**Second Request for Additional Information – ANP-10286P**

**“U.S. EPR Rod Ejection Accident Methodology Topical Report”**

**Response to Second Request for Additional Information – ANP-10286P  
“U.S. EPR Rod Ejection Accident methodology Topical Report”**

**Figure 25-1—Calculation Flow Interfaces**

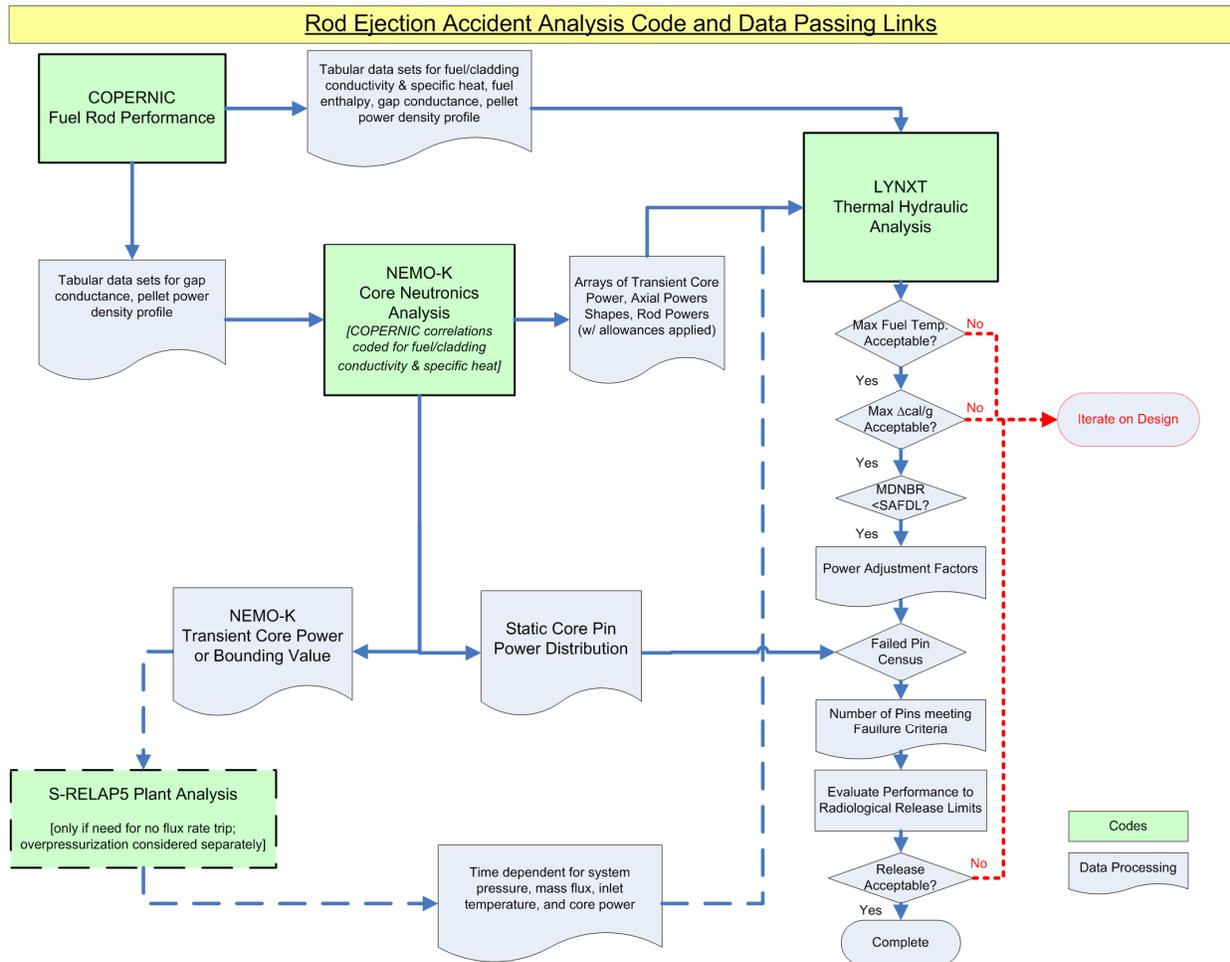
**RAI-25.** *Supply and describe a flowchart on code and data process linkages that explain the analysis flow path for the REA event.*

A flowchart on code and data process linkages is presented in Figure 25-1.

COPERNIC calculations are run to obtain gap conductivity tables for both NEMO and LYNXT. The fuel property correlation equations from COPERNIC are used in NEMO-K. The fuel property equations from COPERNIC are used to create fitting tables in LYNXT for conductivities and heat capacities for the clad and fuel.

The ejected rod transient is simulated with NEMO-K at each of the plant initial conditions outlined in the topical. The core power,  $F_{\Delta H}$  for the peak pin of interest, and axial powers versus time are extracted from NEMO-K and processed to create inputs for LYNXT.

Figure 26-1—Fraction of Power versus Transient Time for BOC REA

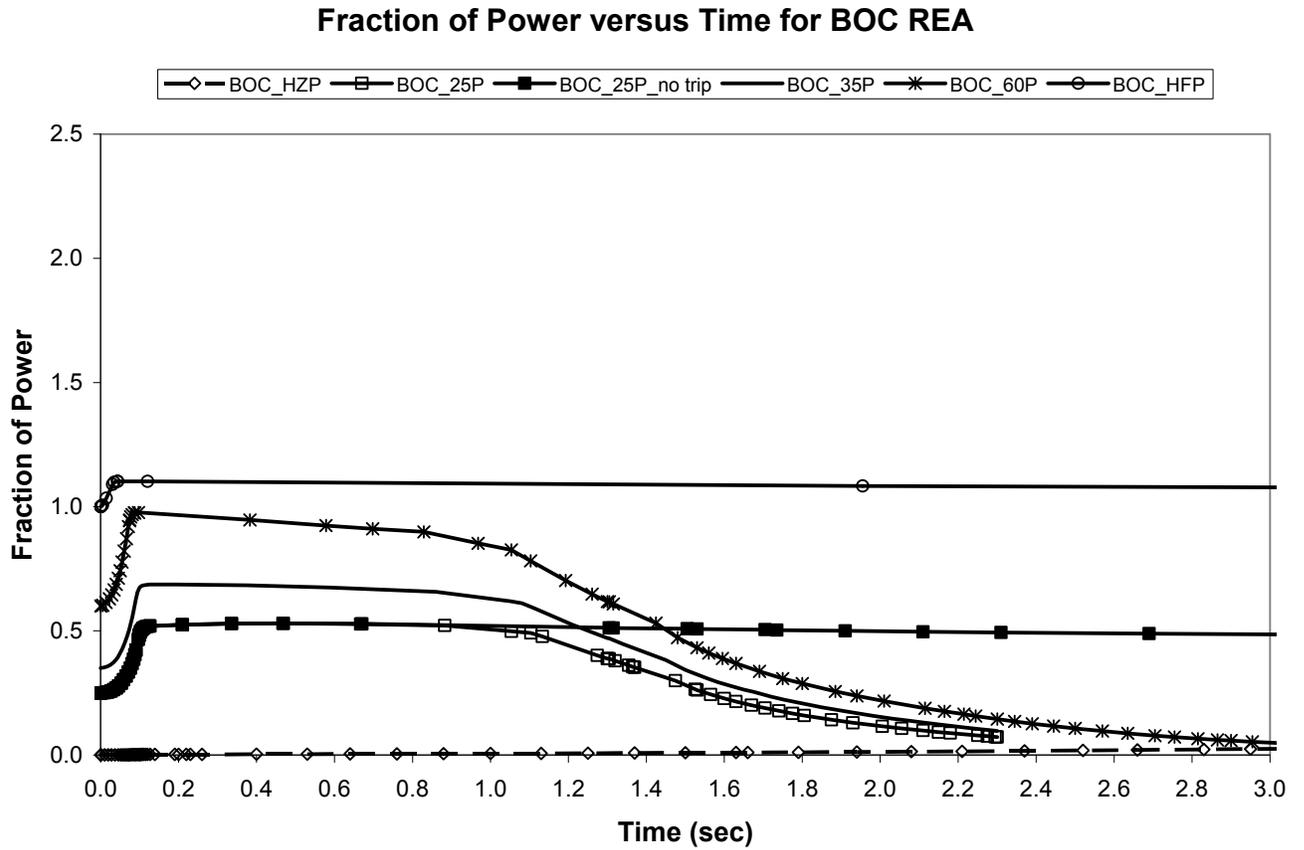
**RAI-26.** Provide an event timeline and description for various REA events (include events that trip and events that don't trip the plant) to explain the parameter responses. Additionally, please explain the process by which the incore DNBR trip time estimates were made.

the times assumed to eject the rods from various power dependent rod positions for BOC and EOC analysis. Table 26-1 also shows the timing sequence to the peak core fraction of power and the minimum or SAFDL MDNBR values. The first one second of the NEMO-K core power histories for the spectrum of power levels considered at BOC and EOC are presented in Figure 26-1 and Figure 26-2, respectively. Each transient has an initial rapid power rise that is limited by the Doppler reactivity feedback of the fuel rod heat up.

**Figure 29-1—Flux Rate Signal Fast Ramp Rate**

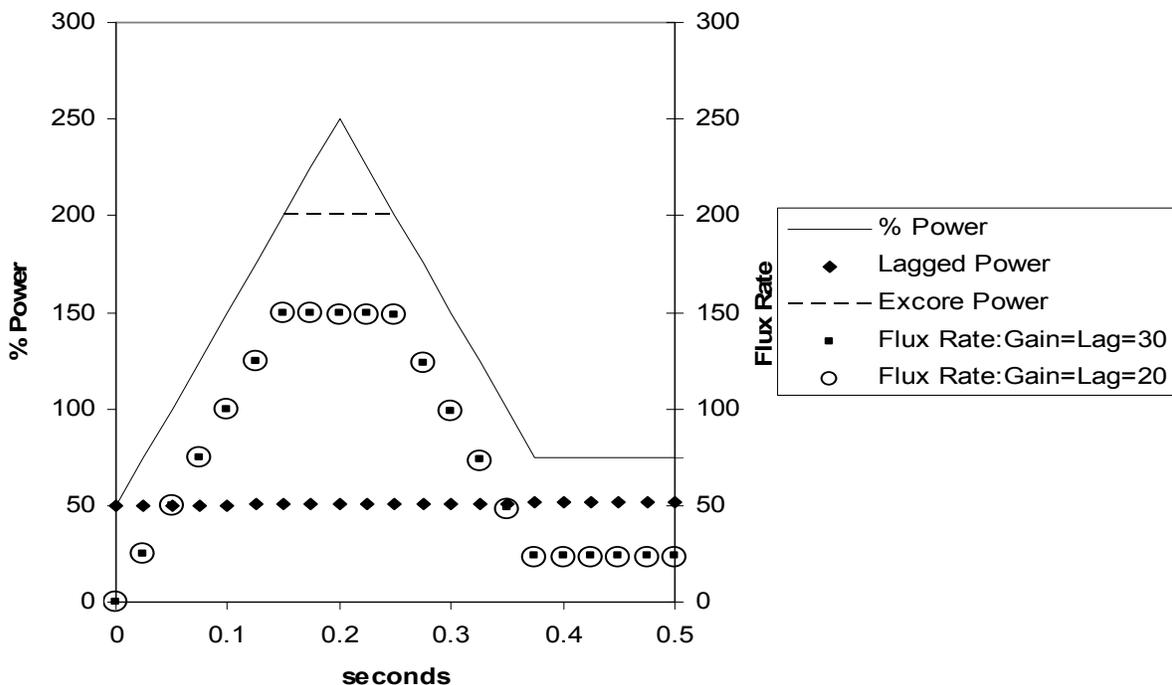
**RAI-29.** *Provide an explanation about the calibration for the high rate flux trip and provide a sample response of the rate lagged filter. (Section 6.2.1, 6.2.1.2, Table 8-1).*

Signal filter responses for a fast and normal ramp rate are shown in Figure 29-1 and Figure 29-2, respectively. The figures show the core power, the lagged power, and the flux rate trip signal versus time for a linear ramp increase and decrease in power. The fast ramp rate simulated in Figure 29-1 is 1%/msec and the normal ramp rate in Figure 29-2 is 10%/minute.

For the fast ramp rate, each point represents a sampling rate of once every 25 milliseconds. The fast ramp rate illustrates the signal response during a prompt excursion. The excore power will indicate no higher than 200 percent power when the actual power is above 200 percent power. For the fast ramp rate figure, the flux rate signal is nearly equal to the delta power observed from  $t=0$  because the lagged power signal does not change in this short time frame relative to the 30 second lag time. The flux rate signal remains high throughout the transient even though the power is going down. The flux rate values for 20 second gain and lag constants is indistinguishable from the values with 30 second time constants. The label of normal ramp rate corresponds to a 10%/minute ramp rate, which is a relatively fast maneuvering rate. Figure 29-2 shows an asymptotic 5 percent rate signal, which agrees with the ramp rate (10%/60 seconds) times the gain constant (30). The flux rate signal with the gain and lag set to 20 reaches its maximum value of 3.3 (10%/60 seconds times 20) more quickly than the gain and lag set to 30.
